CPCI J1

PCIE TO PCI BRIGE

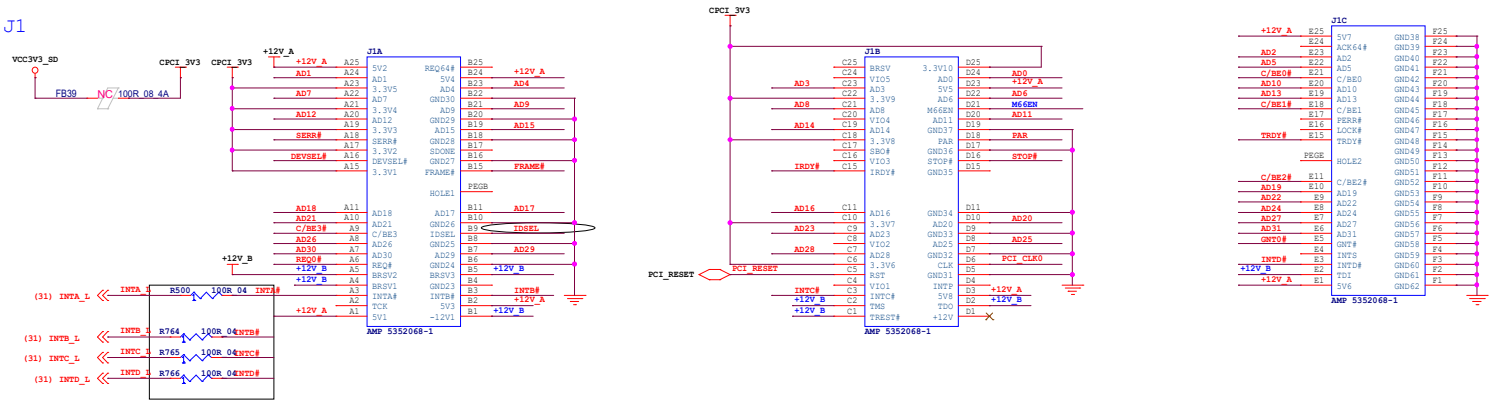
电阻换成100R_0 4 0 2

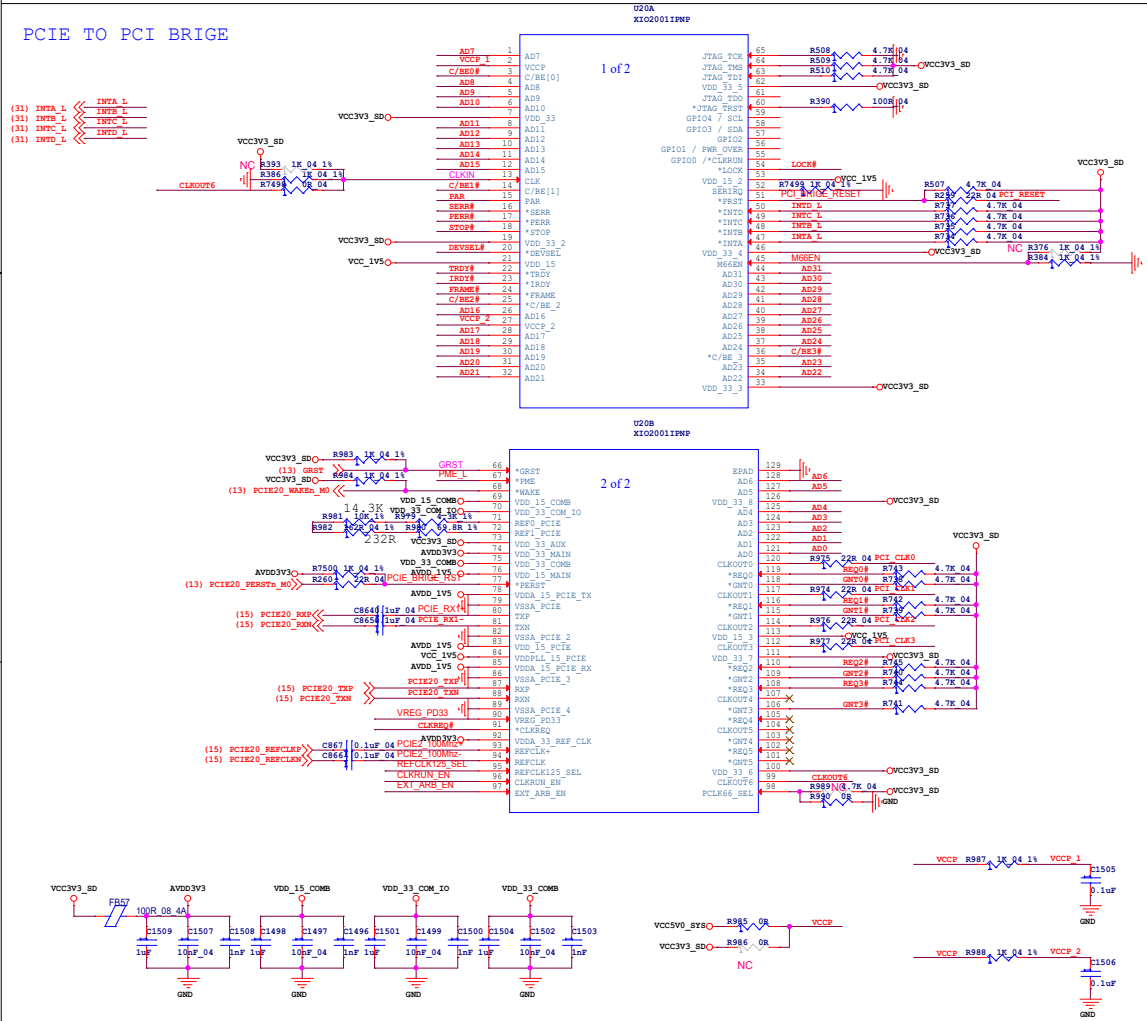
采用内部时钟源
